SHEET: A5
DRAWN BY: SJB
PLAN: MAIN LEVEL
LAUNDRY
REVISIONS:
2 MAY 26

PHIL & MICHELLE WOOD
3435 N. 140TH. CIRCLE
OMAHA, NE 68164

WOOD
5588

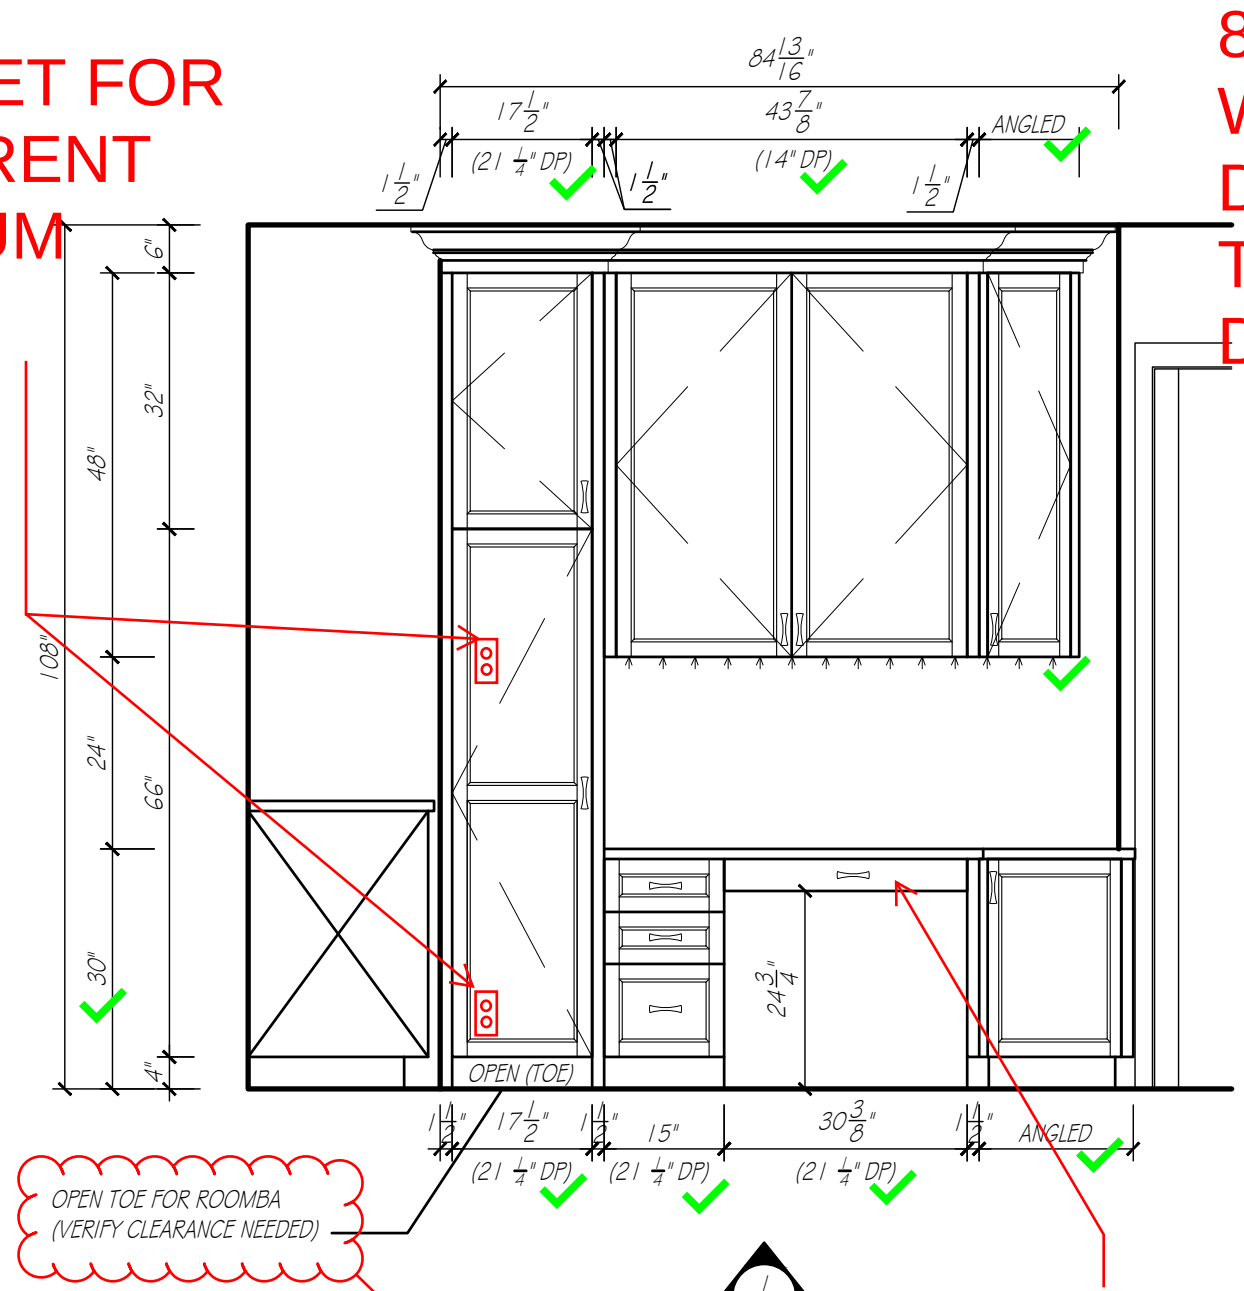
OUTLET HIGH
& OUTLET LOW
INSIDE
CABINET FOR
DIFFERENT
VACUUM
TYPES

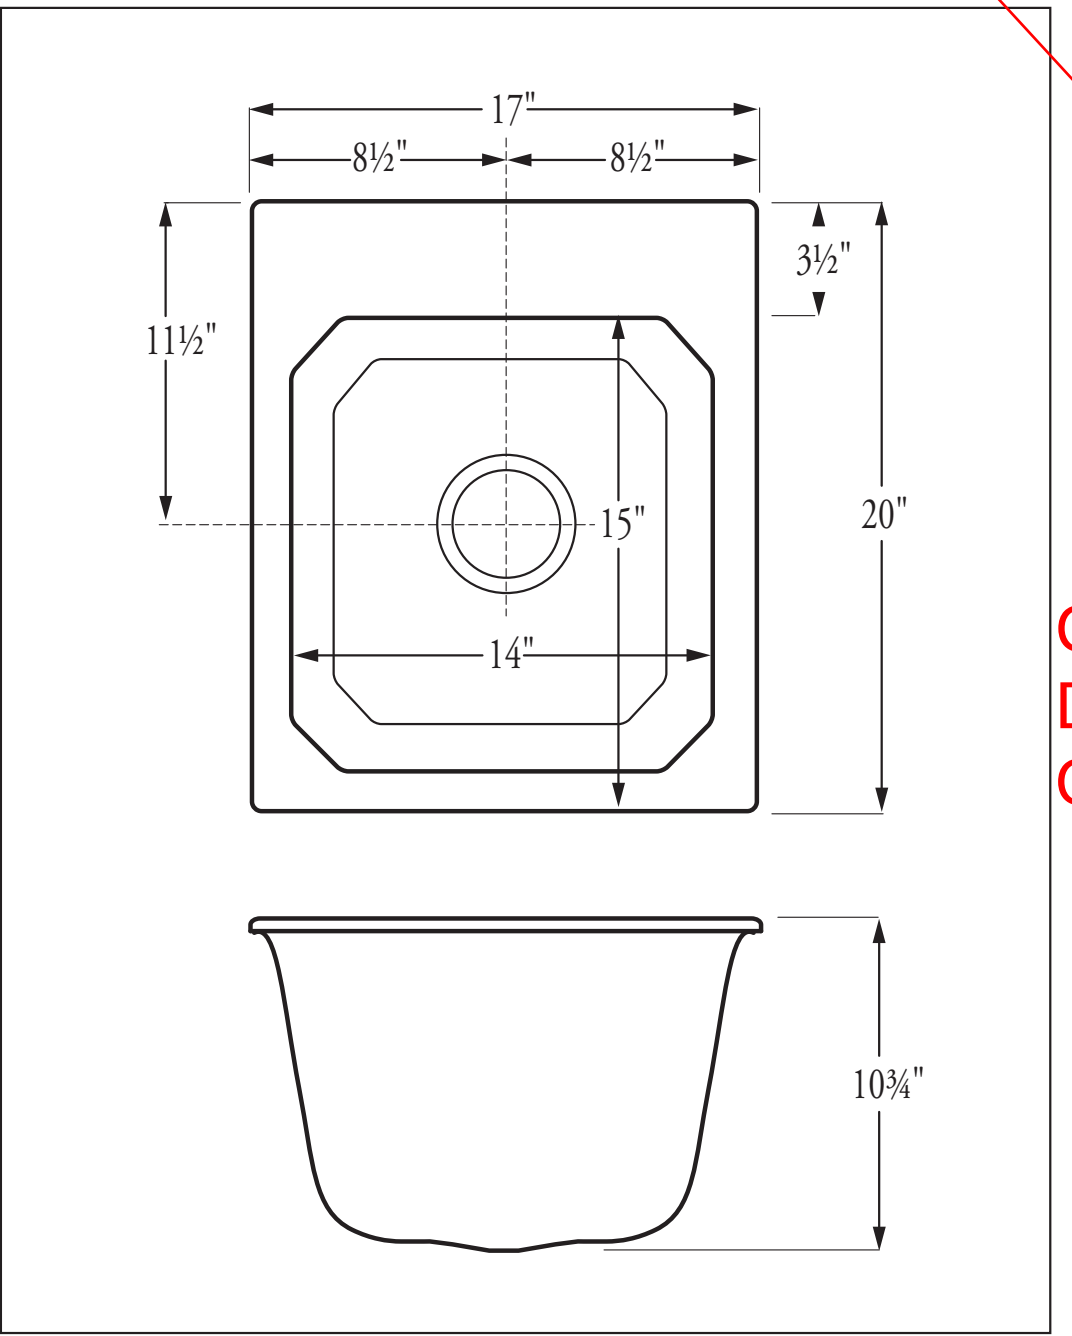
8" DRAWER - THEY
WANTED A DEEPER
DRAWER THAN
TYPICAL TOP
DRAWER

FUTURE
DOG
AREA

KEYBOARD
DRAWER -
NOT FULL
DEPTH TO
ALLOW FOR
GROMMET IN
TOP

5" FROM FINISHED
FLOOR TO
BOTTOM OF DOOR
- "The Eufy X10 Pro
Omni is among the
taller standard robot
vacuums at
approximately 4.47
inches (113.5 mm)
in height."

CONCERNED ABOUT SINK
DEPTH - INTERIOR DEPTH
OF CABINET????

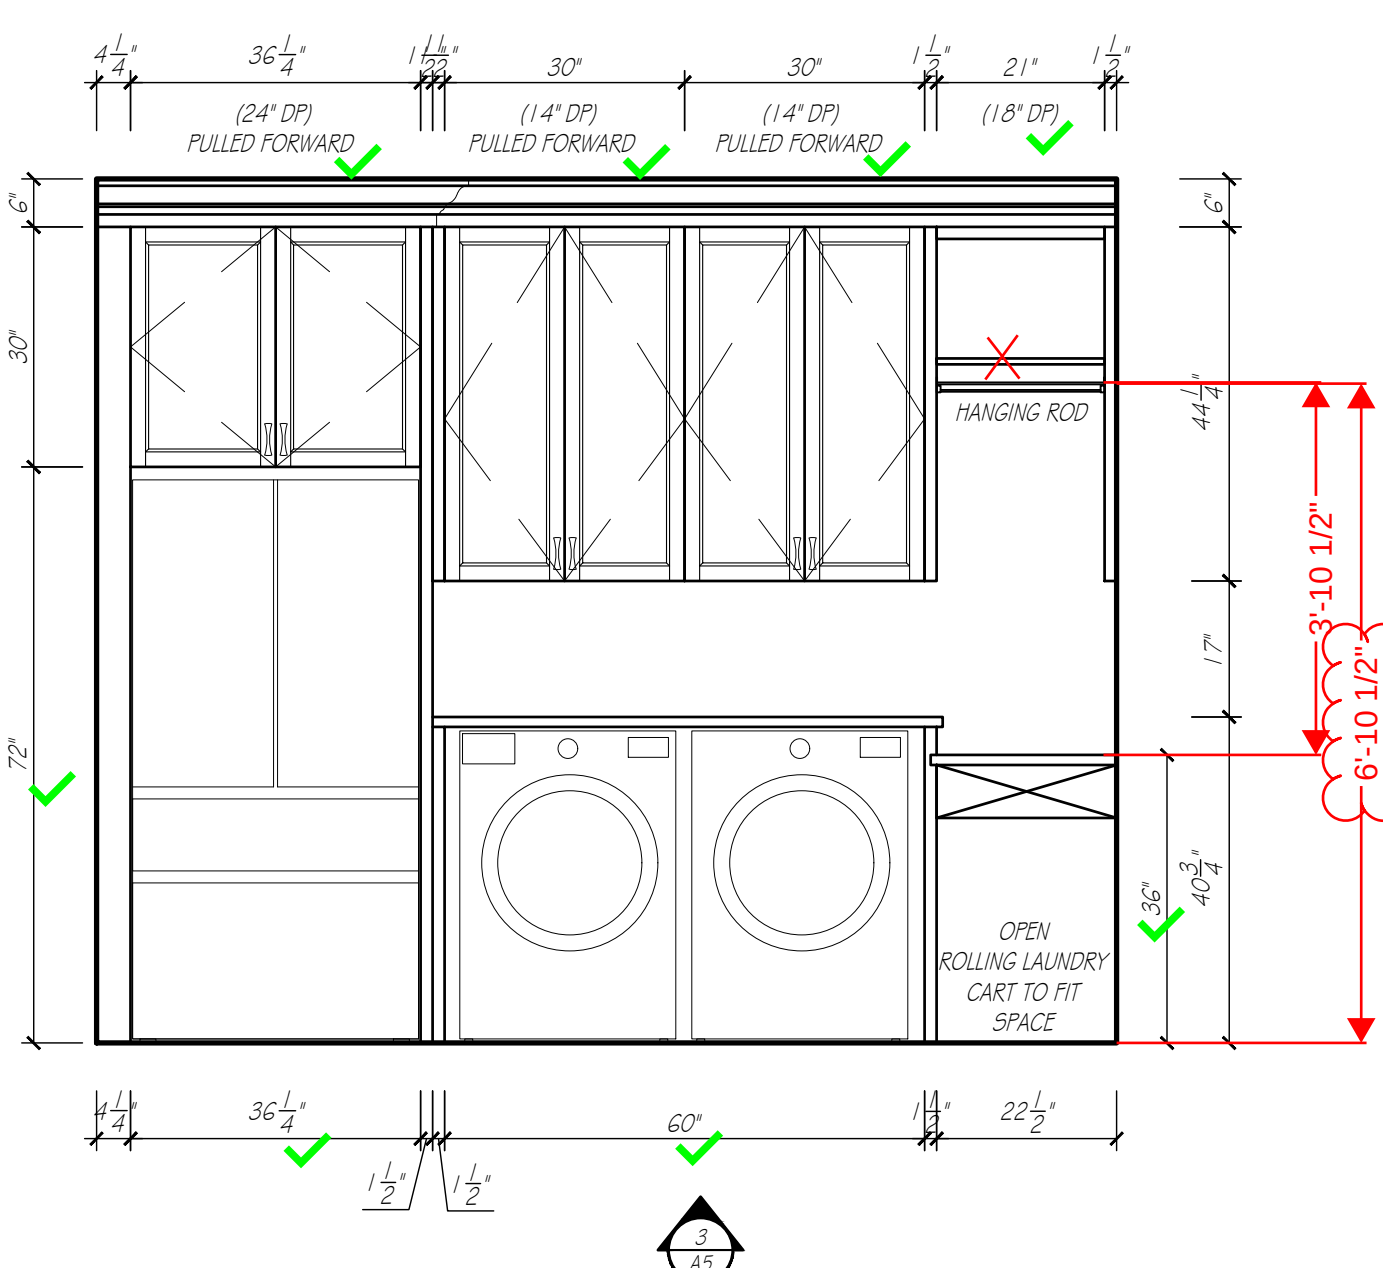
LIGHT SWITCH FOR
UNDER CABINET
LIGHTING

THIS IS NOT
REACHABLE

CROWN BY MCNEIL -
TO TIE INTO ROOM
CROWN

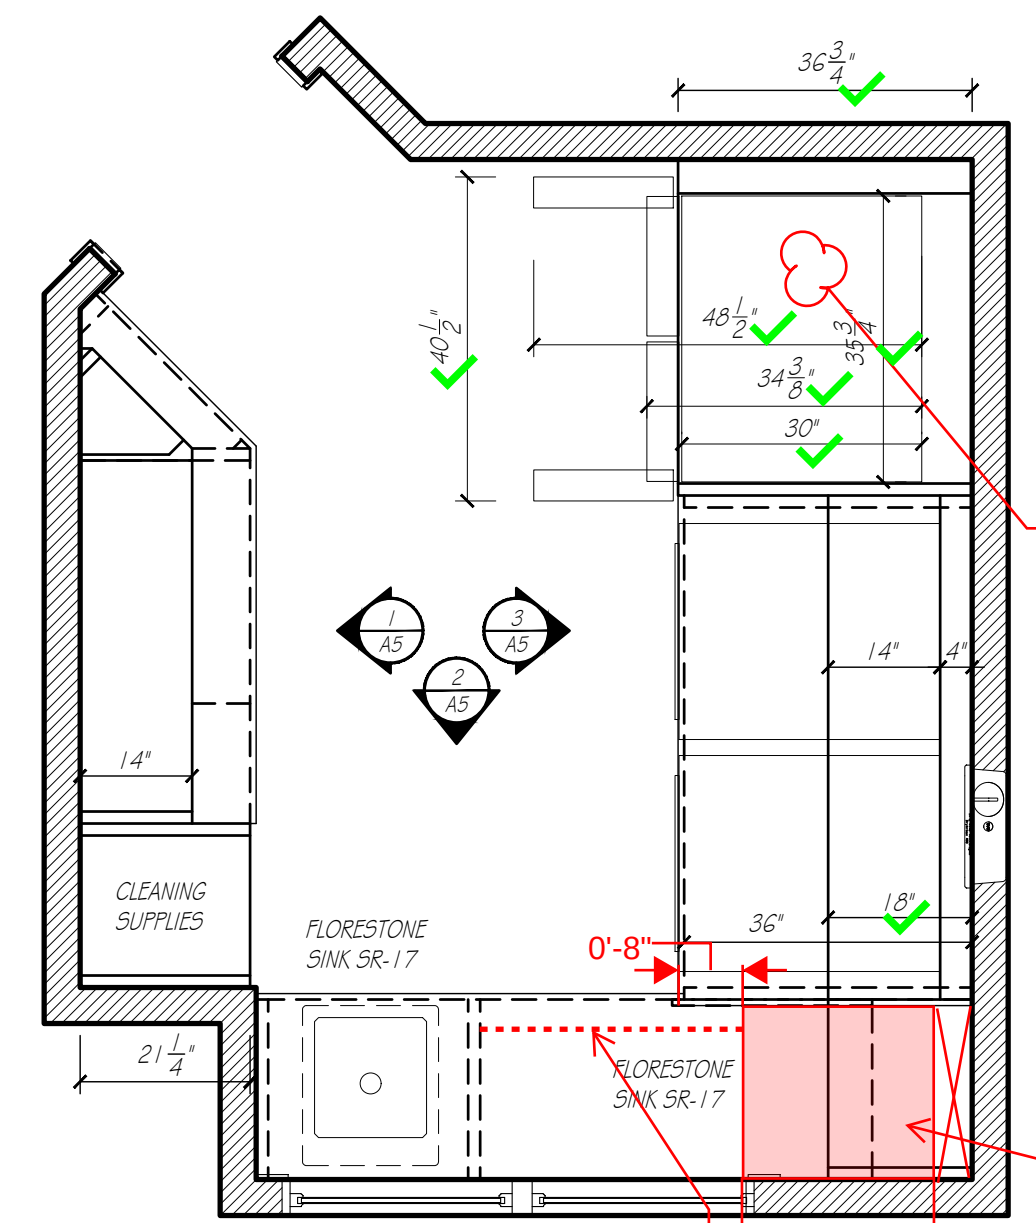
NO PLUGMOULD -
OUTLETS IN
BACKSPLASH

LED CHANNEL LIGHT
UNDER CABINET IN
OPEN SPACE

24"D ADJUST. SHELVING UNDER
WITH FUTURE DOG SPACE, 8"
FROM FRONT CORNER, LEAVE
DEAD SPACE BEHIND (HAVE
DRYER DUCT IN THIS AREA)
